RE: Data Responses, Set 2A
Cosumnes Power Plant (01-AFC-19)

**COSUMNES POWER PLANT
(01-AFC-19)**

DATA RESPONSE, SET 2A

REVISIONS NO. DATE DESCRIPTION _____ _____ _____	
Drawing Scale AS NOTED	D22
Project Number 13440	Drawing No. D2101701
Date Issued 10-15-00	Type CIV

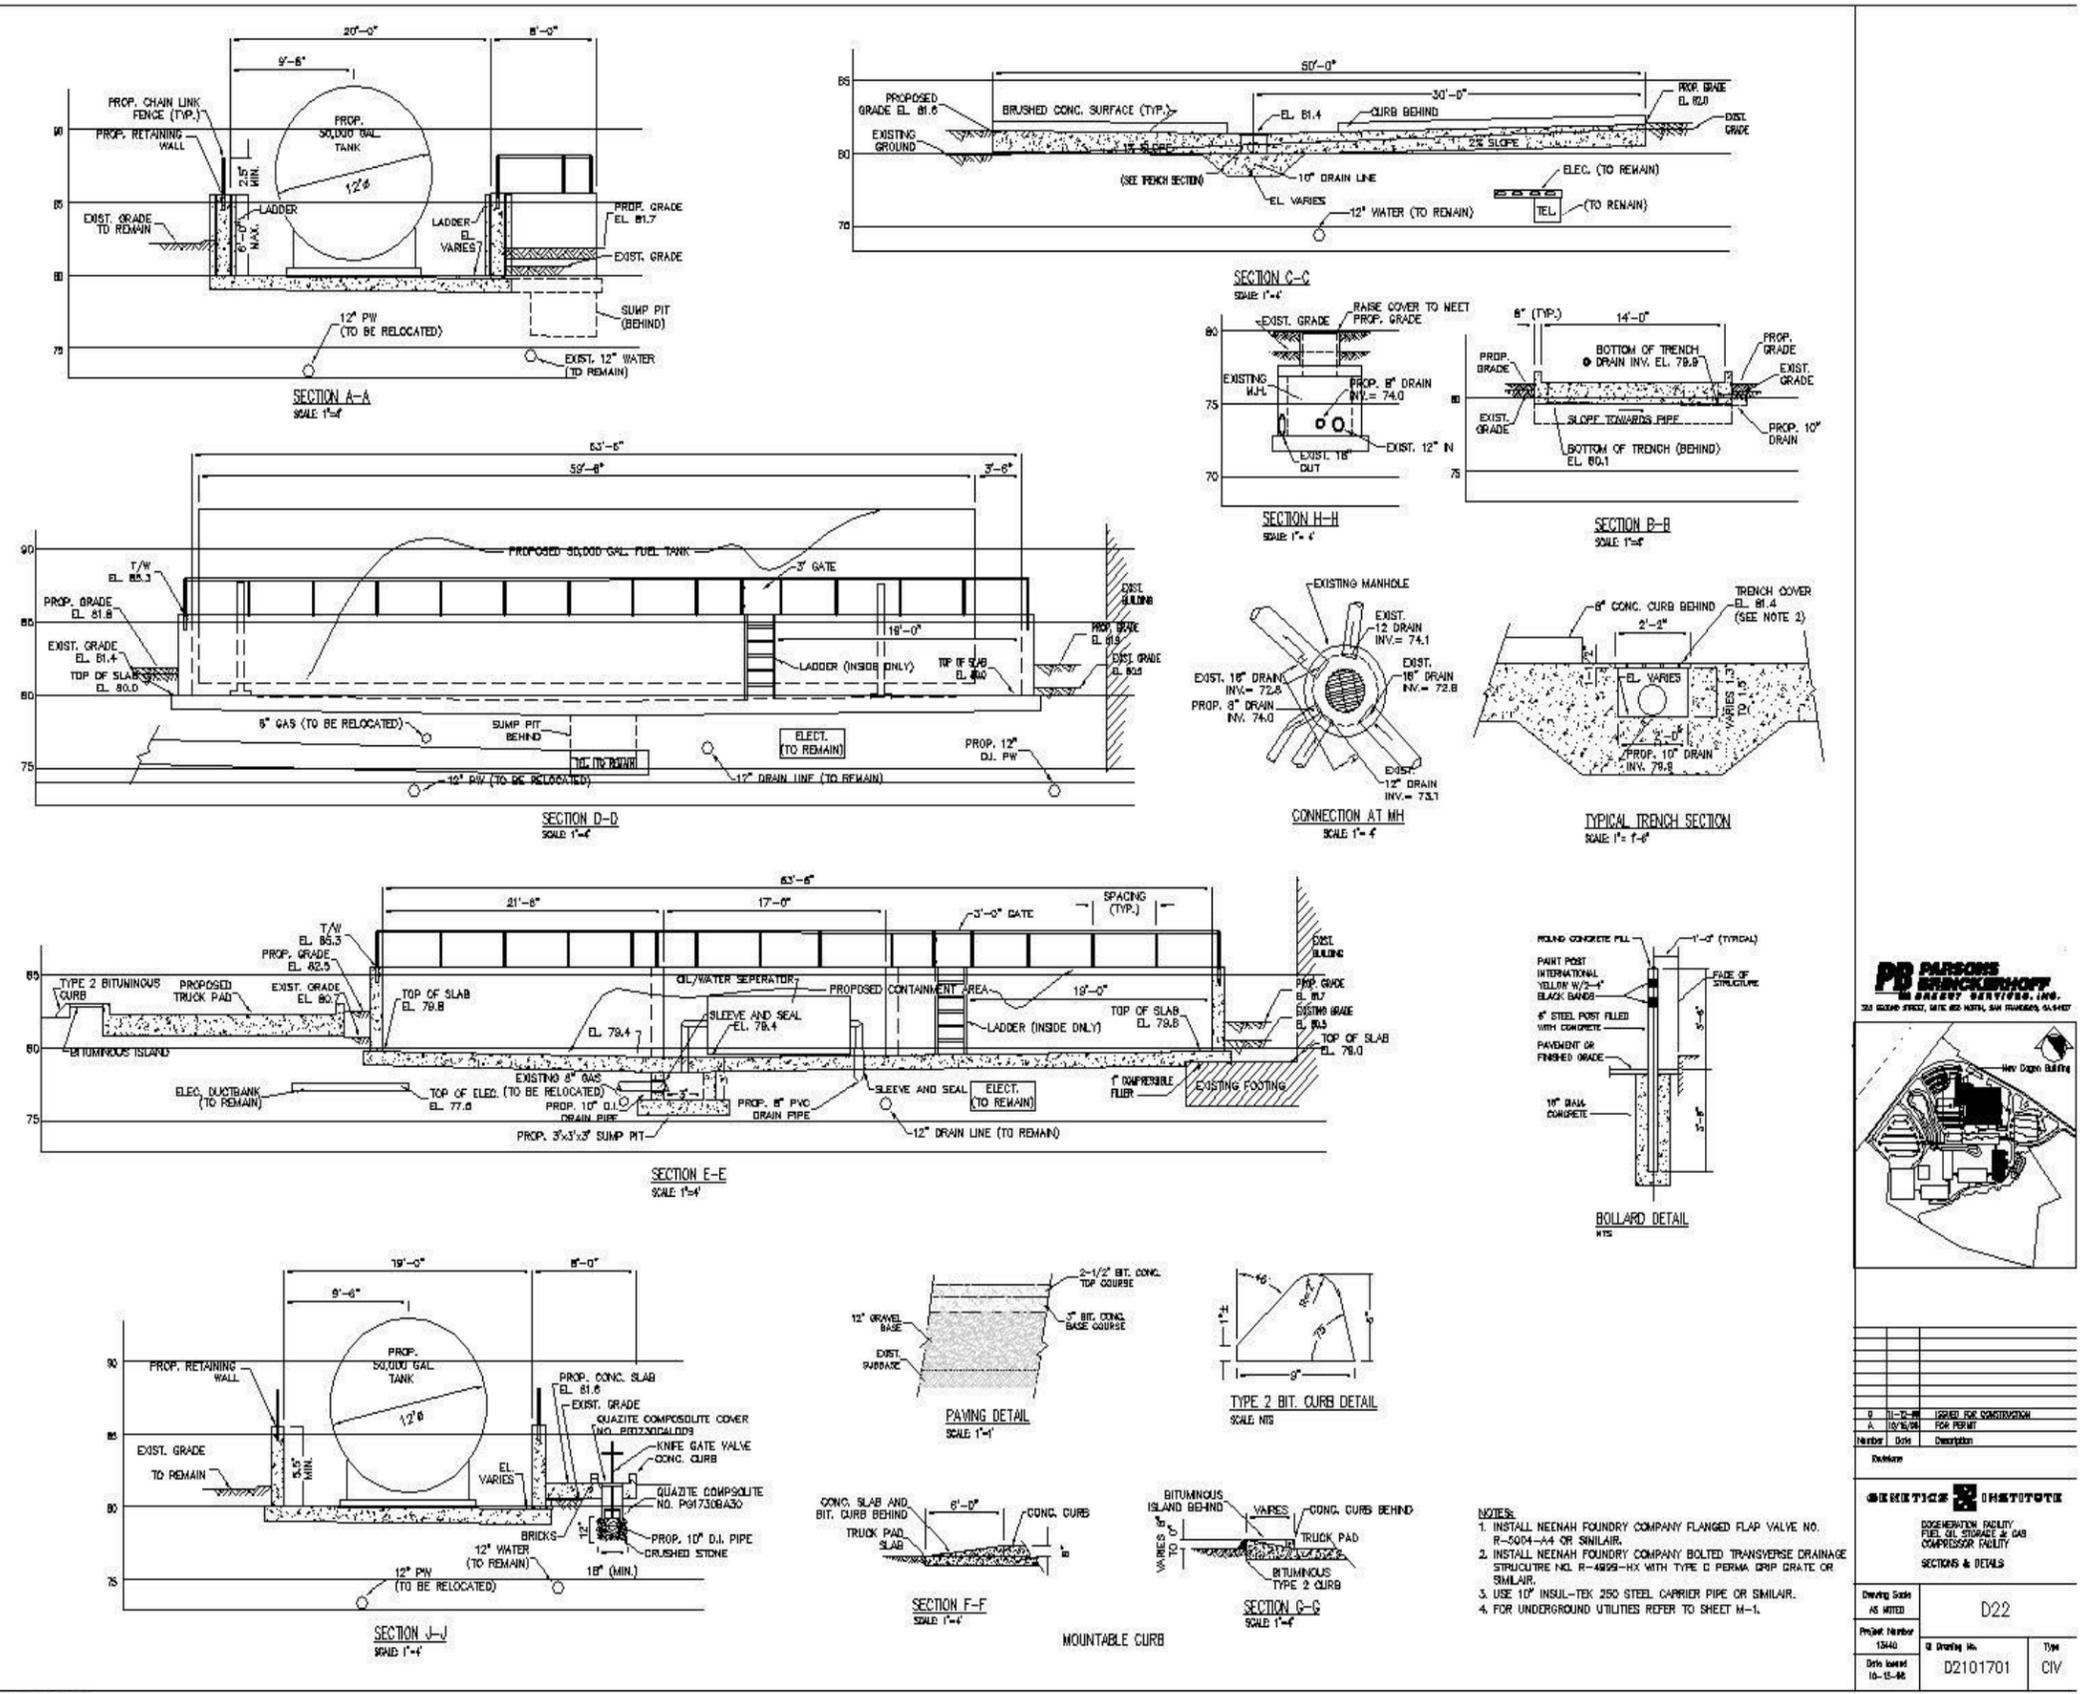
182. Please provide a schematic diagram and narrative describing the proposed catch basin under the aqueous ammonia storage tank and delivery vehicle transfer pad.

Response: Detail design of an ammonia storage tank and delivery vehicle catch basin is still several months away. However, the Applicant has provided drawings and a description of a typical unloading system for a distillate oil tank,

noting that the ammonia unloading system at CPP will contain similar features. These drawings are included as Attachments HM-182a and b.

A bulk delivery truck parks on the designated apron. This apron has a slight curb around the periphery (similar to a “speed bump”) and the apron is also sloped such that the area drains into a trench drain. The trench drain would collect any spill within the curbed area and drain into the spill containment surrounding the storage tank. Spill containment capacity for the storage tank is significantly greater than a delivery truck so the containment volume does not require an increase in size to handle a possible delivery truck spill. The unloading hose connection area is also curbed and drains toward the trench should any liquid release occur during or after unloading from the hose or connection.

The drain from the storage tank containment area is valved and only opened manually. This valve will be opened as necessary to drain collected rain water and will remain closed at all other times. As with all equipment drains or spill containment drains, this drain goes to an oil- water separator before going to the wastewater treatment system. If there is a spill the drain valve will remain closed and the proper removal techniques will be employed in accordance with the NPDES and Stormwater Pollution Prevention Plan to safely remove and dispose of any spillage
